## Proposal for amendments to

### ECE/TRANS/WP.29/2020/81

The text reproduced below was prepared by the experts from the ‘task force on testing’ lead by JRC/EC. The proposal is aimed at modifying the text of document ECE/TRANS/WP.29/2020/81 (Regulation 157 on ALKS). All modifications to ECE/TRANS/WP.29/2020/81 are given in **blue** text. Deletions are indicated by ~~red-strikethrough~~ text.

#### 1. Cut in

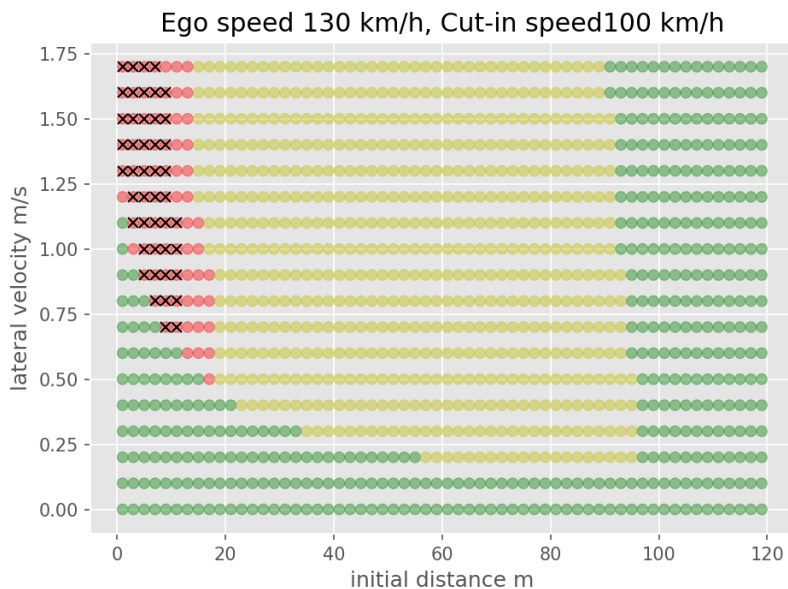
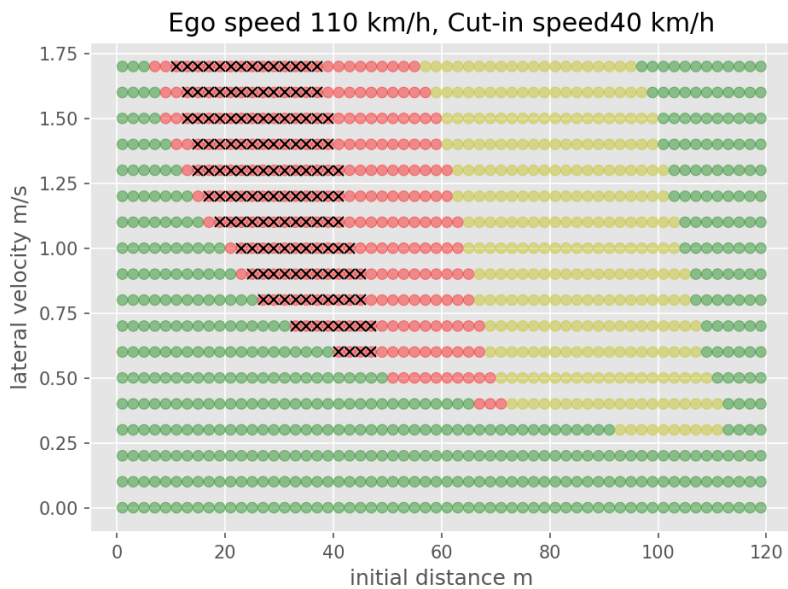
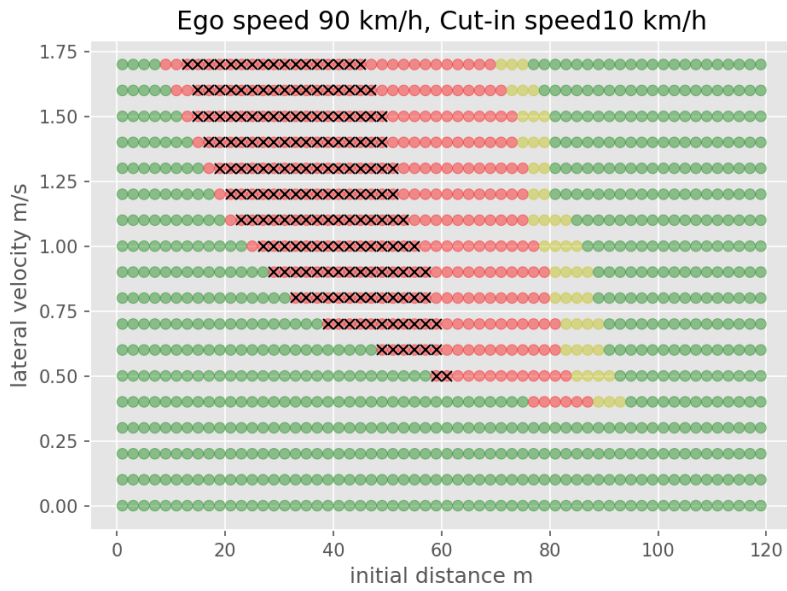
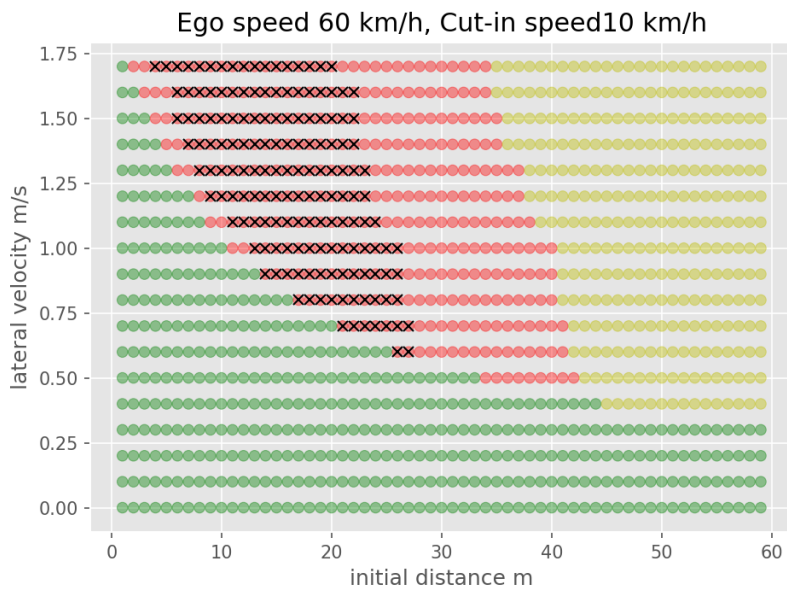
**Kommentiert [PKT11]:** KBA: What is the definition of PFS and CFS?

2. Cut out

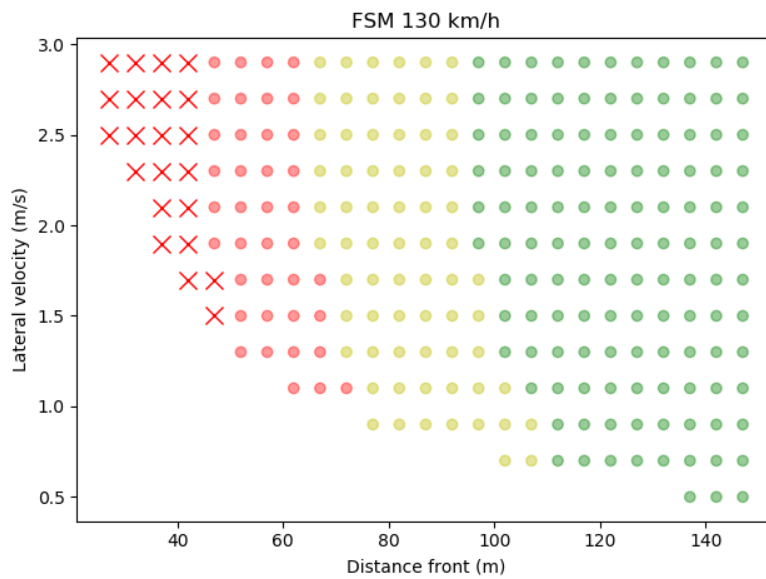
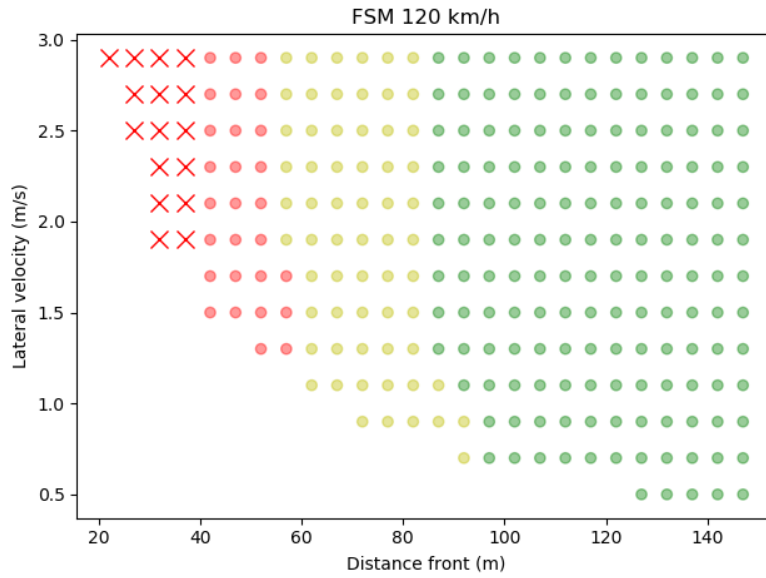
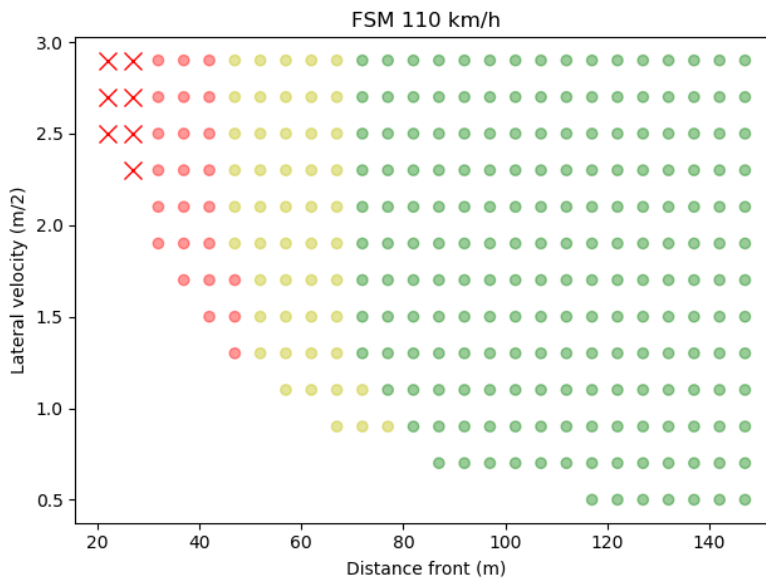
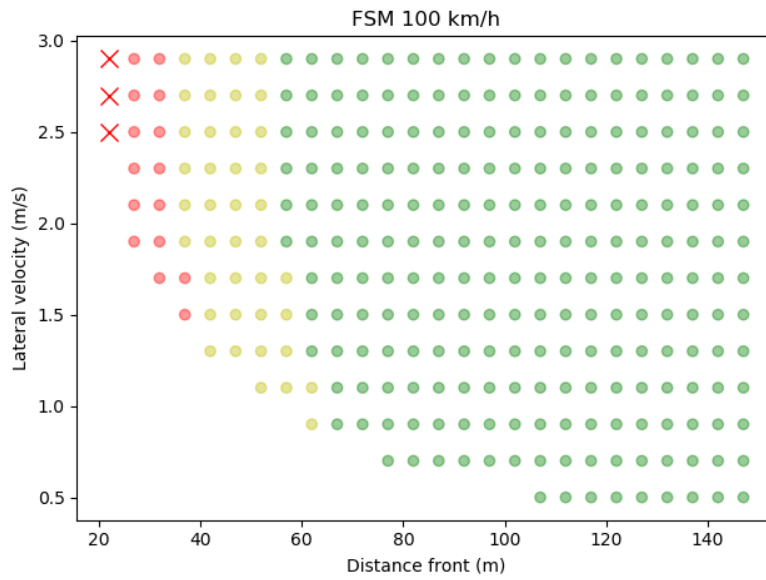
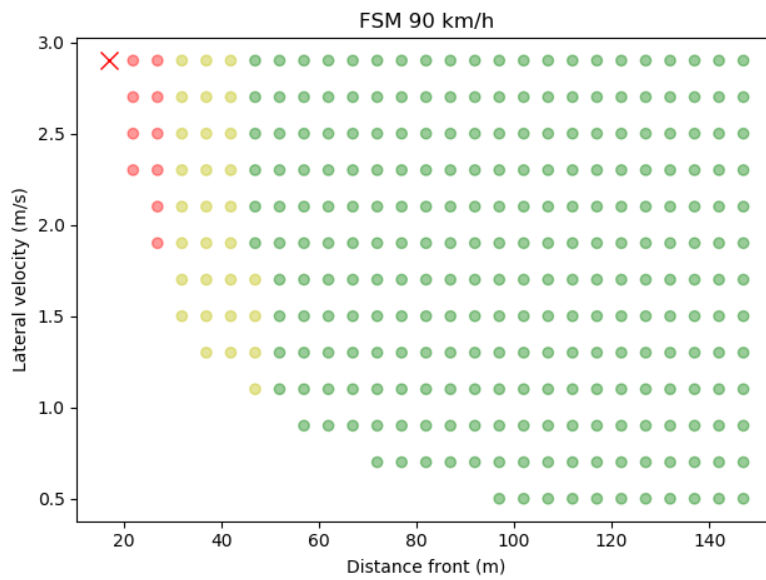
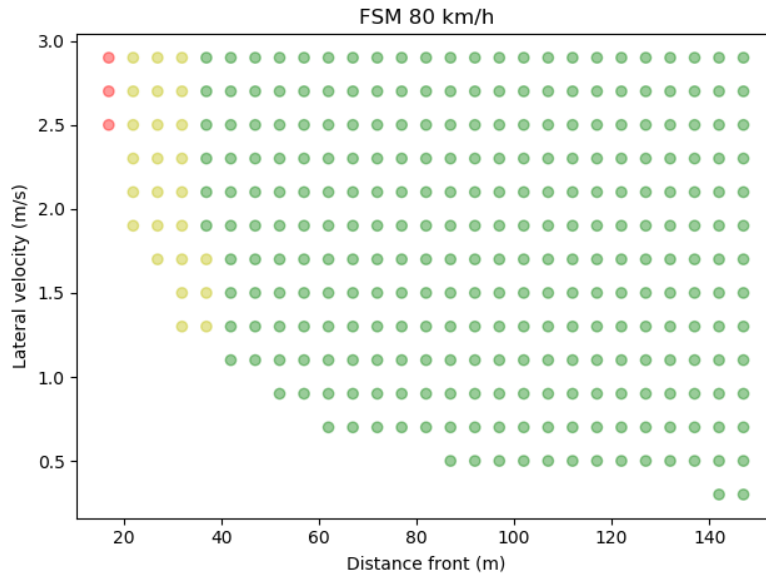
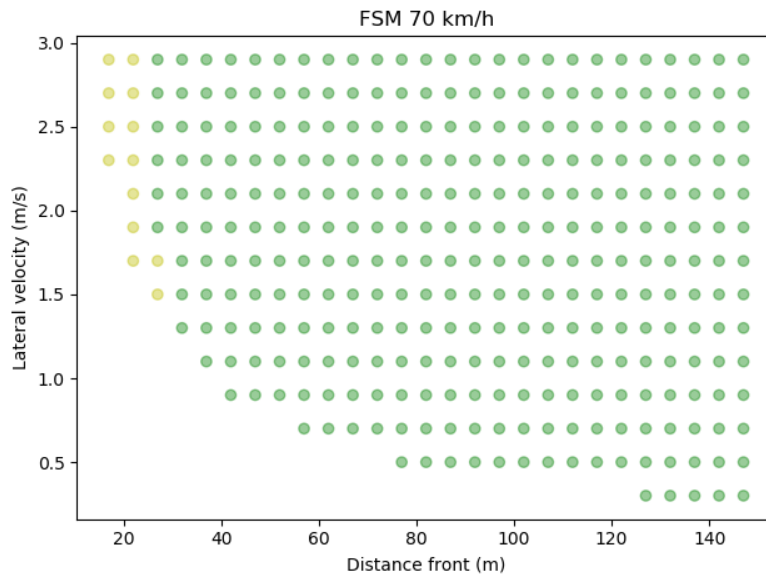
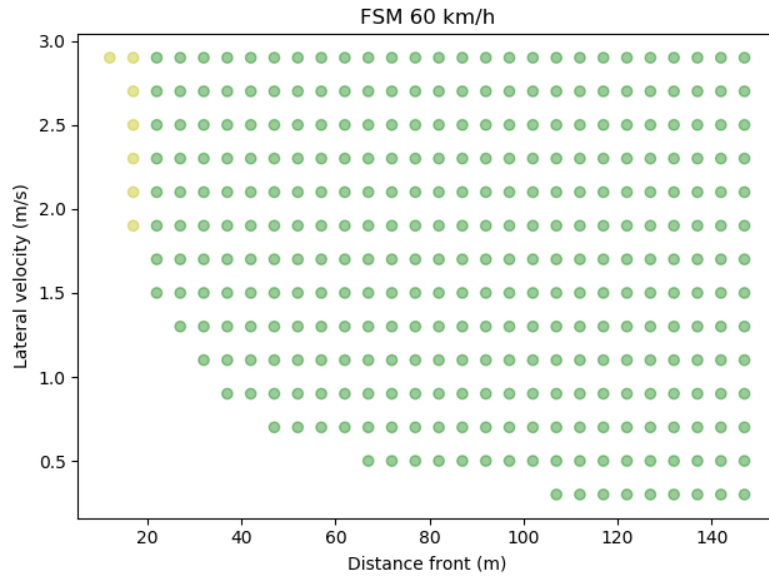
**Kommentiert [PKT13]:** KBA: Should be replaced by "Type-approval authorities"

Figure 13  
Deceleration

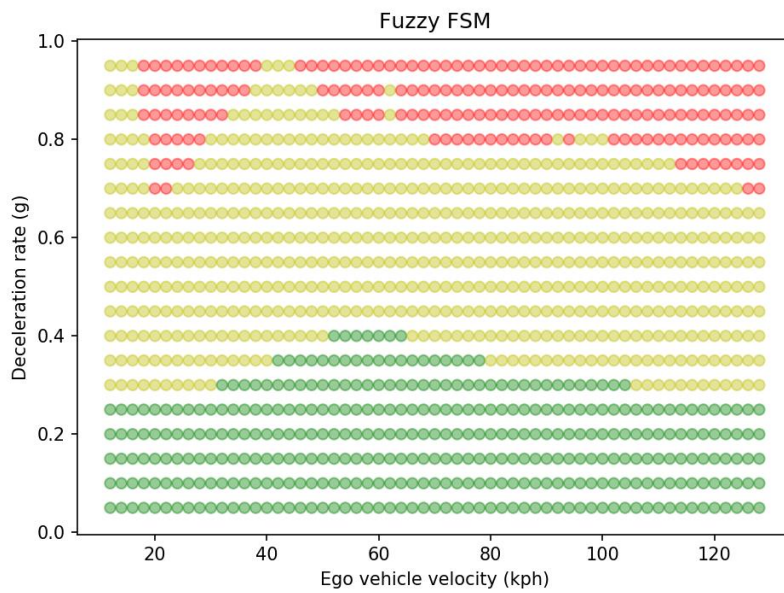
**Kommentiert [PKT14]:** KBA: Should be replaced by "Type-approval authorities"
